PROJECT JO HERDT ADDITION DATE 2-6-84
JOB NO. _____
TO Chris Breitenstein
FROM N. Brent Wooten
REFERENCE Final Drainage Plan

1-5-84
Drainage plan

SKETCH PLAT JO HERDT ADDITION

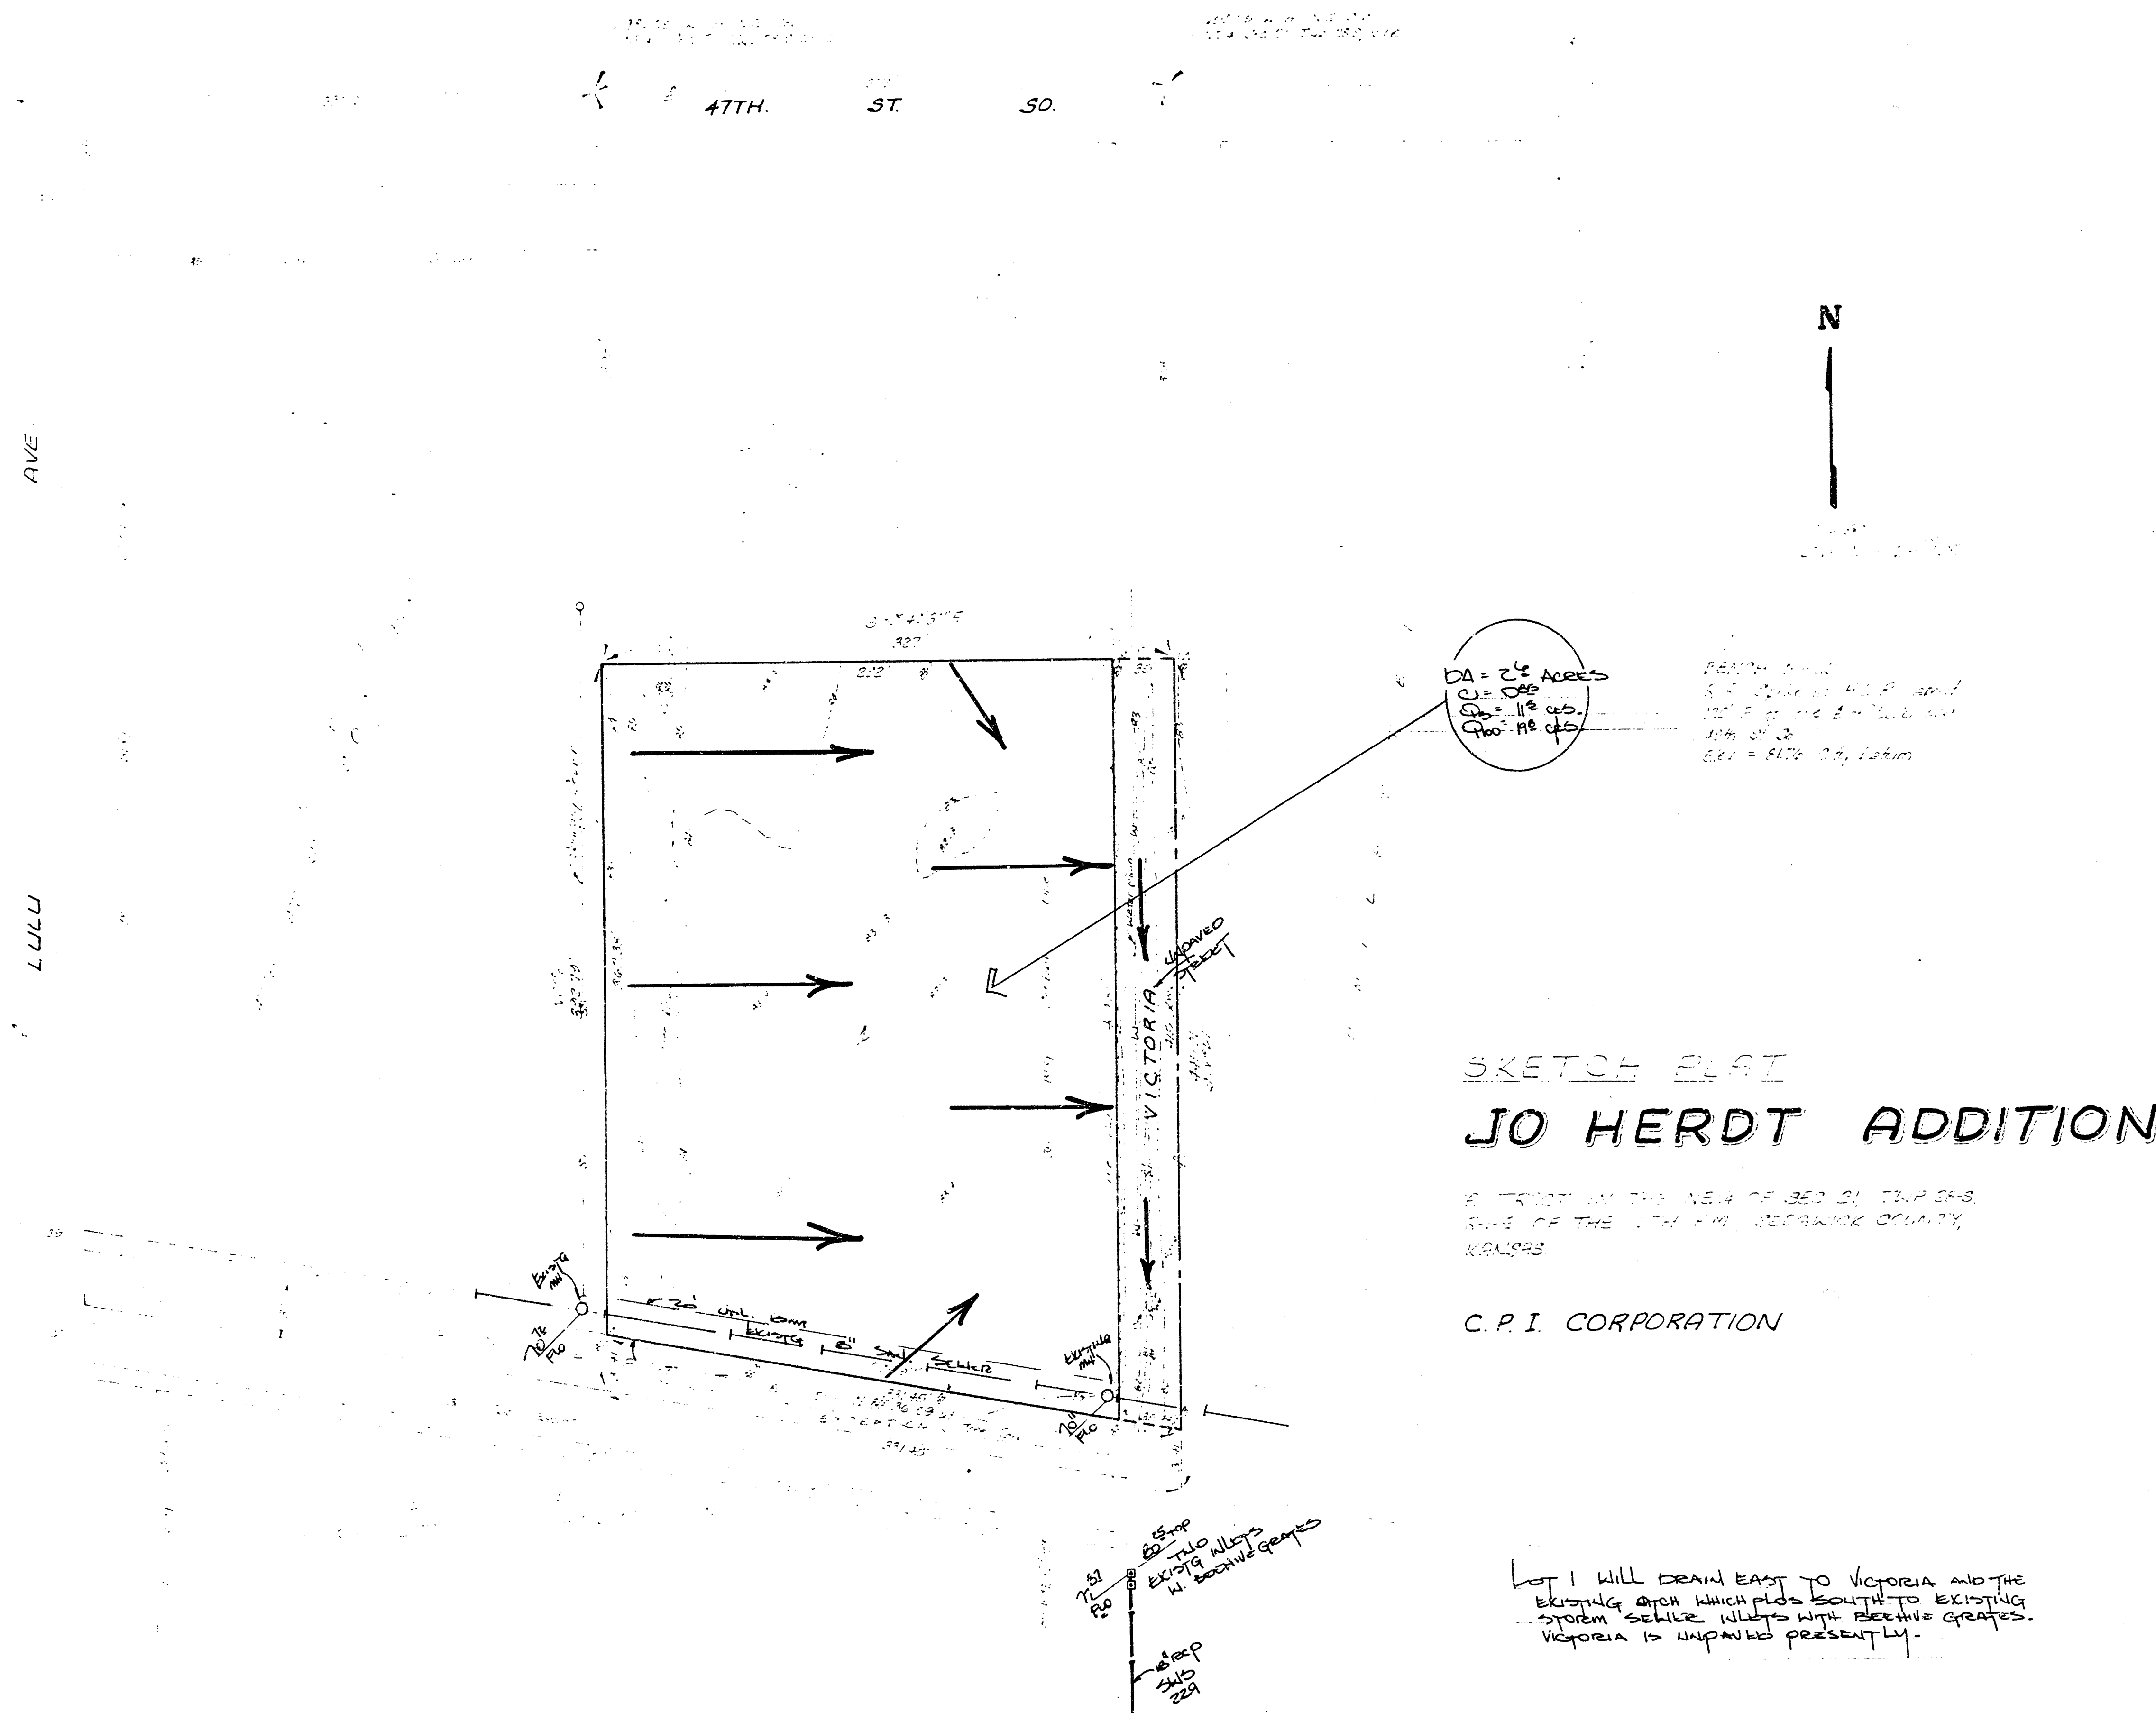
Draw to unpaved st.

B+C) drain to unpaved st.

OK with O+N?

Do we require guarantee to pave adjacent to plat?
